DENDROBIUM MINE WATER MANAGEMENT PLAN

Document ID	DENMP0065	Version	8.0	Page 1 of 109
Last Date Updated	4 August 2023	Next Review Date	4 August 2026

DOCUMENT REVISION LOG

Figure 1: Water Balance Summary – FY23 (volumes in ML)

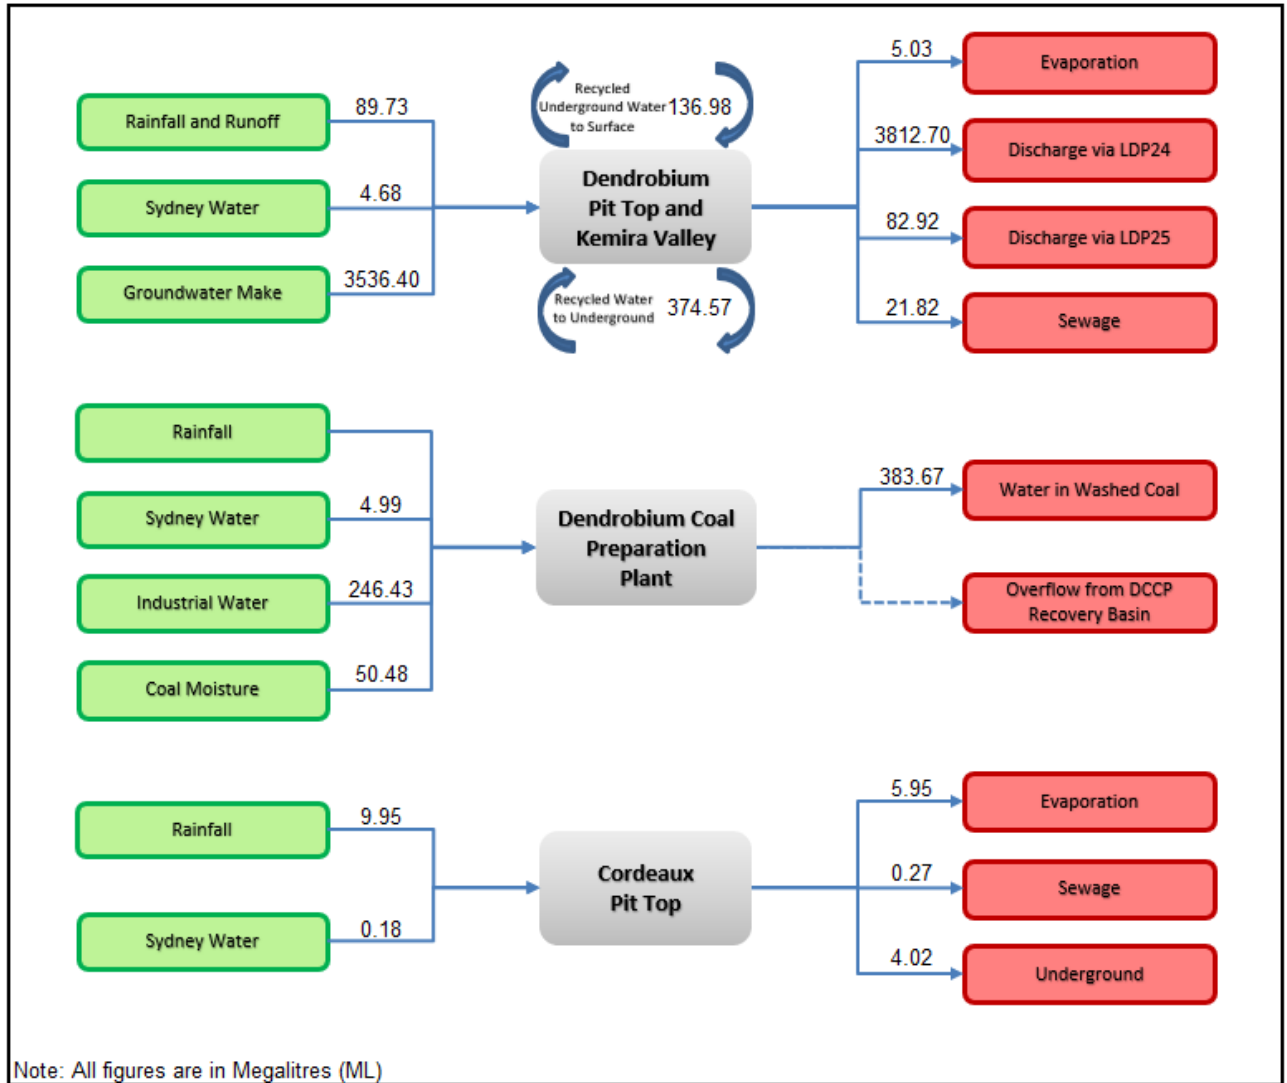
Update reference to the <i>Australian Drinking Water Guidelines</i> (2011) to the current version	Updated.
In Figure 1, water balance values for outgoing water values are updated, but incoming water are presented the same as the old figure. Check and revise Figure 1 to present recent water <i>source</i> and <i>recycled</i> volume values in Figure 1 – Water Balance Summary.	FY23 data has been provided.
Section 5.2.3.2 states that the <i>Gas Drainage Plant – Area 3C - Construction Erosion and Sediment Control Plan (Version 3 dated 15 December 2022)</i> provides further detail including plans and specific erosion and sediment control management measures (including during operational phase) at the site, however a link to- or copy of- the December 2022 Construction Erosion and Sediment Control Plan is not provided in the WMP.	Management measures from the plan have now been incorporated in this section.
